Highland Falls – Fort Montgomery Central School District

James I. O'Neill Renovation Project

Addendum No. 3

September 28, 2021

AD3/E-303

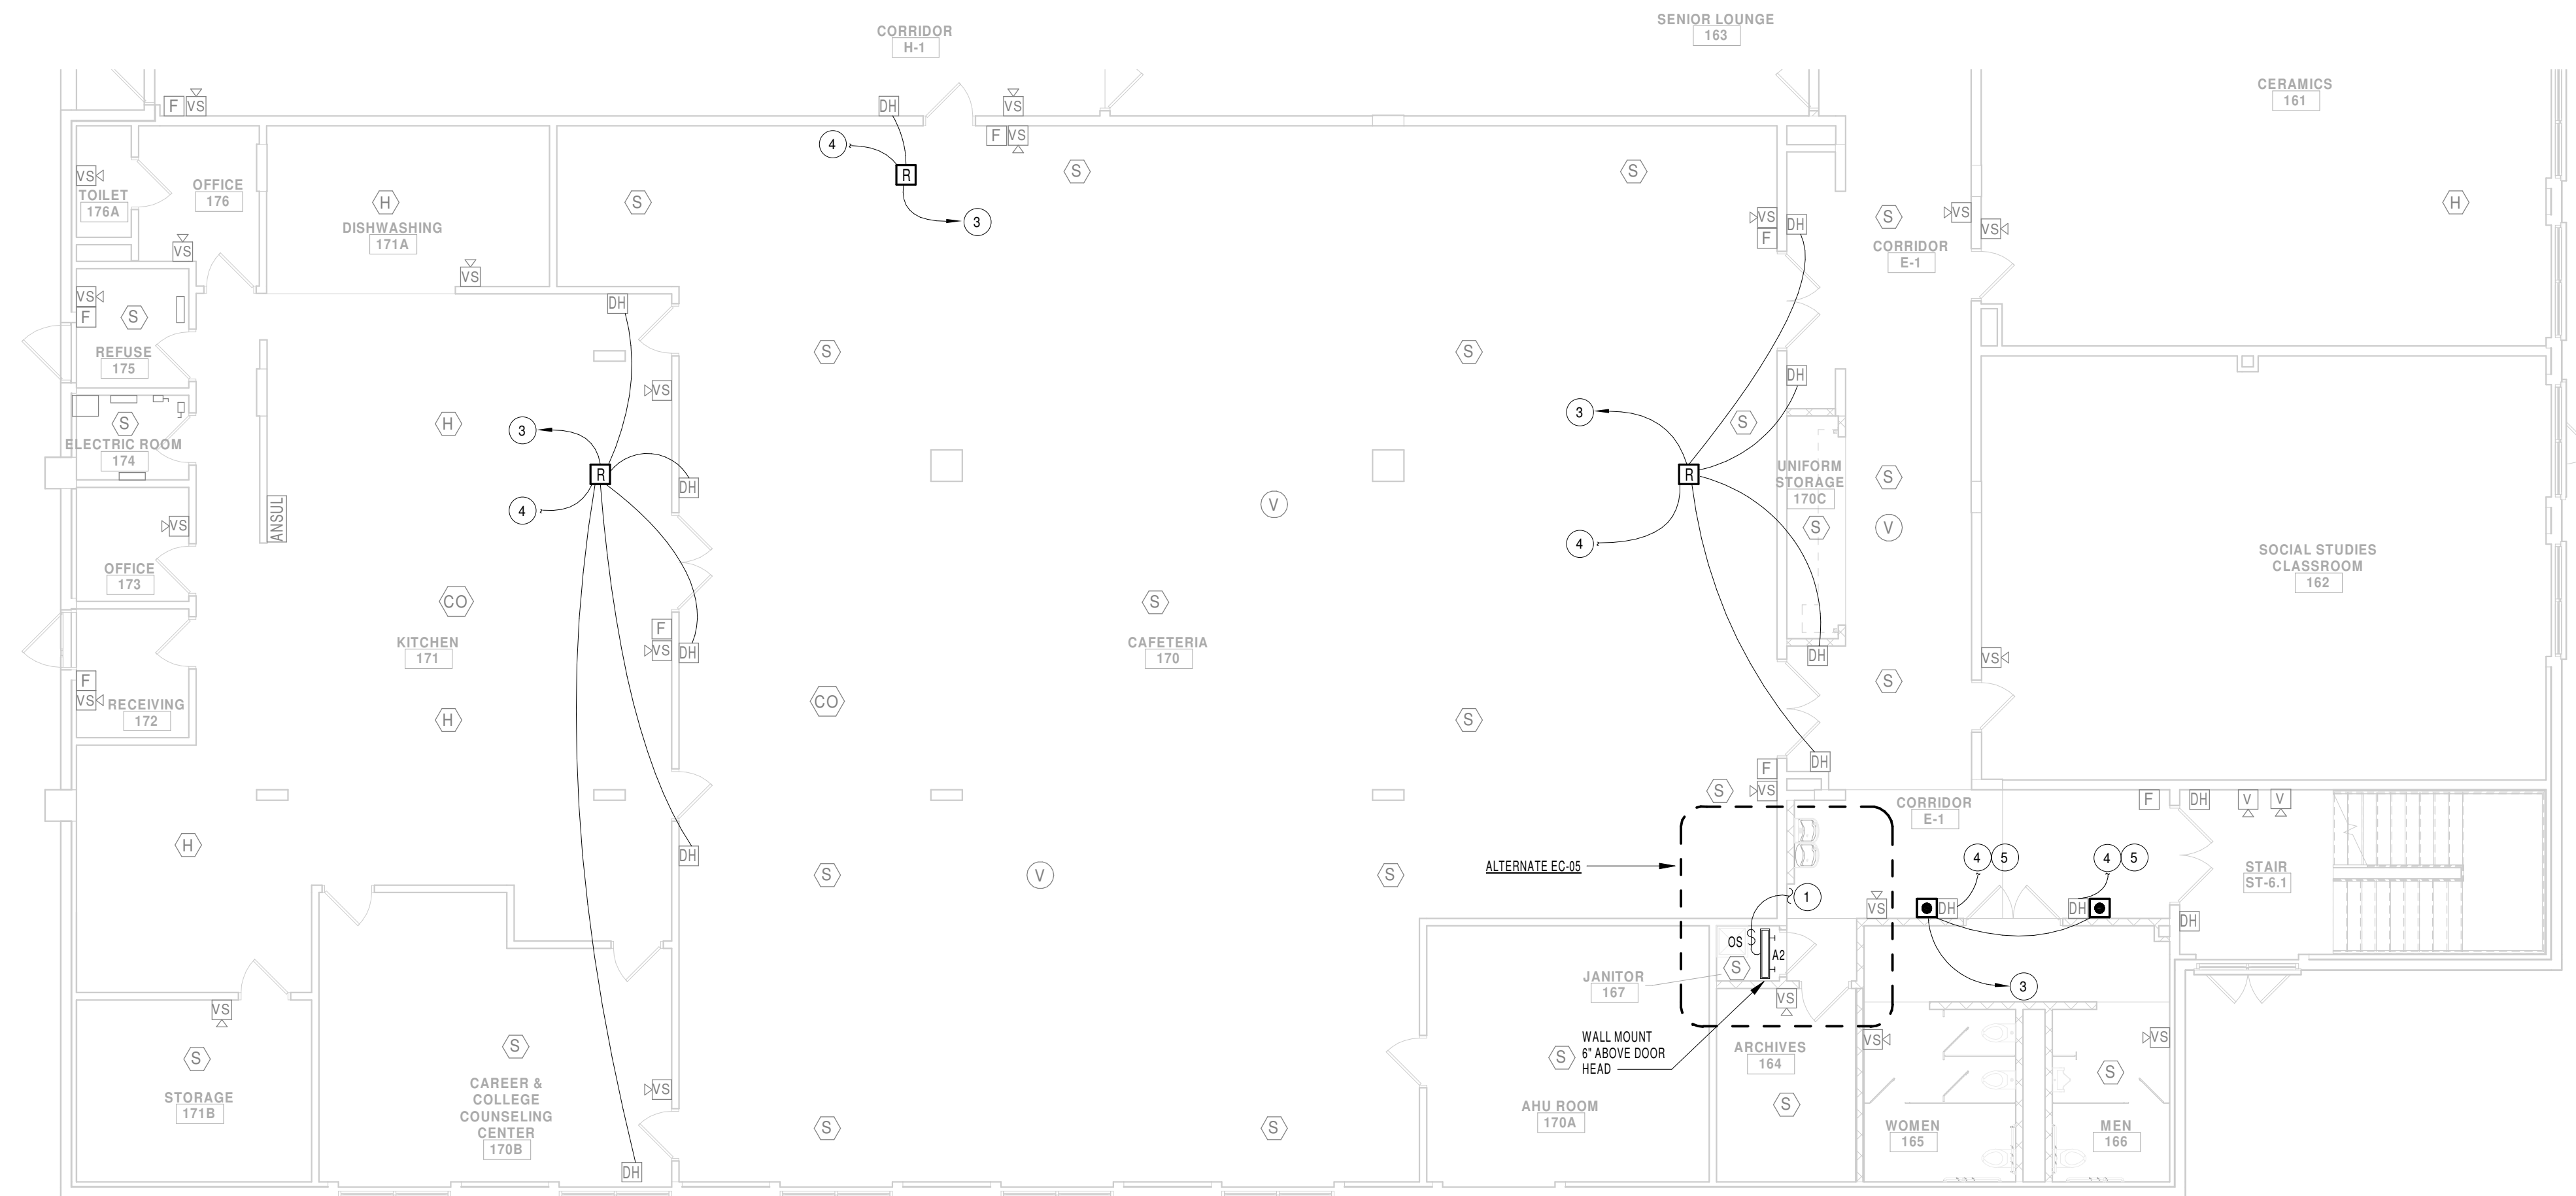
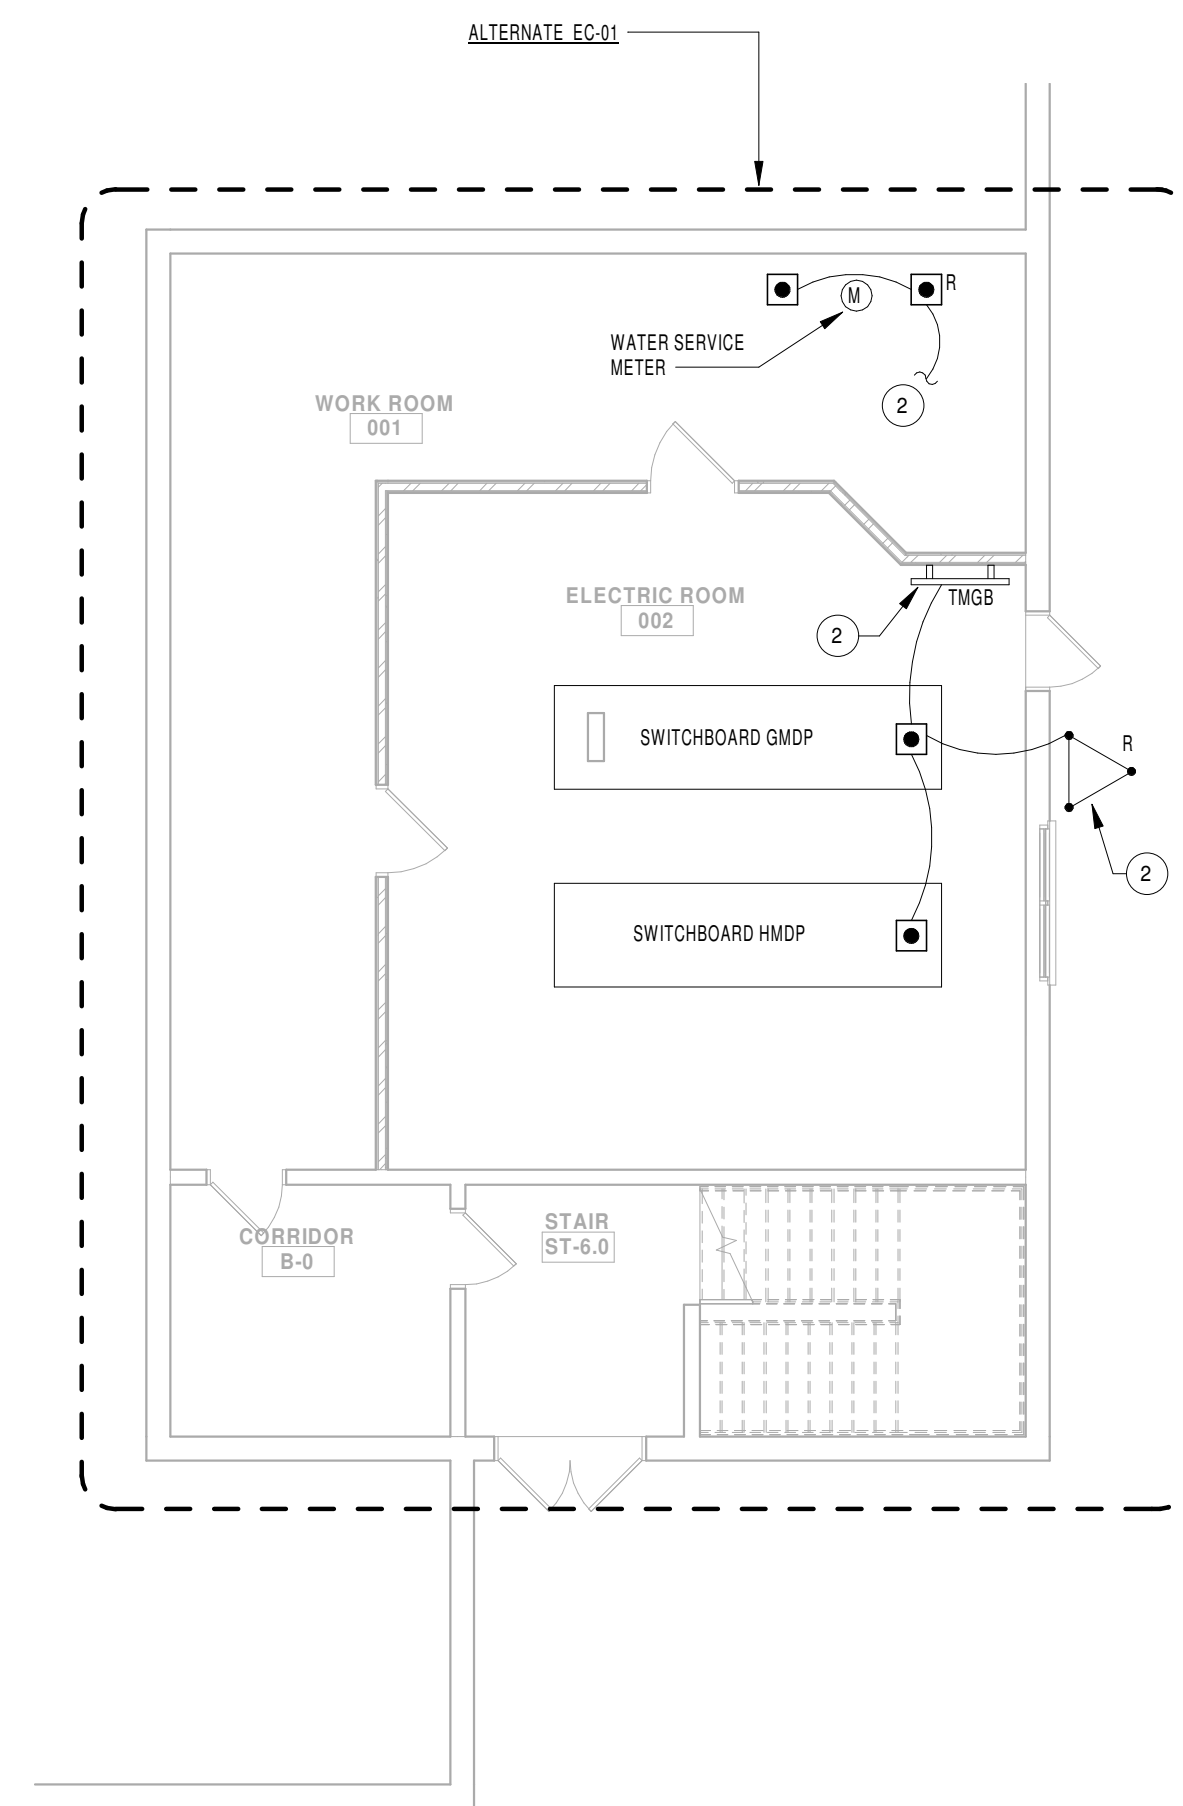
“P9. SURFACE MOUNT PACKAGED POWER SUPPLY ON BACKSIDE OF MARQUEE MASONRY STRUCTURE, ON INSIDE FACE. FIELD COORDINATE INSTALLATION LOCATION AND MOUNTING CONFIGURATION WITH GENERAL CONTRACTOR. UNIT IS TO BE POSITIONED TO MINIMIZE VISUAL IMPACT. COORDINATE EXACT PLACEMENT OF UNIT WITH ARCHITECT AND OWNER IN FIELD DURING PRE-CONSTRUCTION MEETING AND UPON SUBMISSION OF COORDINATION SHOP DRAWINGS WITH GC. FIELD COORDINATE ROUTING OF CONDUITS FROM PACKAGE POWER SUPPLY TO EACH OF THREE SIGN CABINETS WITH GC PRIOR TO COORDINATION DRAWING SUBMITTAL SUBMISSION.
- E. Refer to Drawing E-303 *Basement & First Floor Area B – Partial Plans*; **DELETE** In its' entirety and **REPLACE** with the attached Drawing BID AD3 / E-303 - *Basement & First Floor Area B – Partial Plans*.
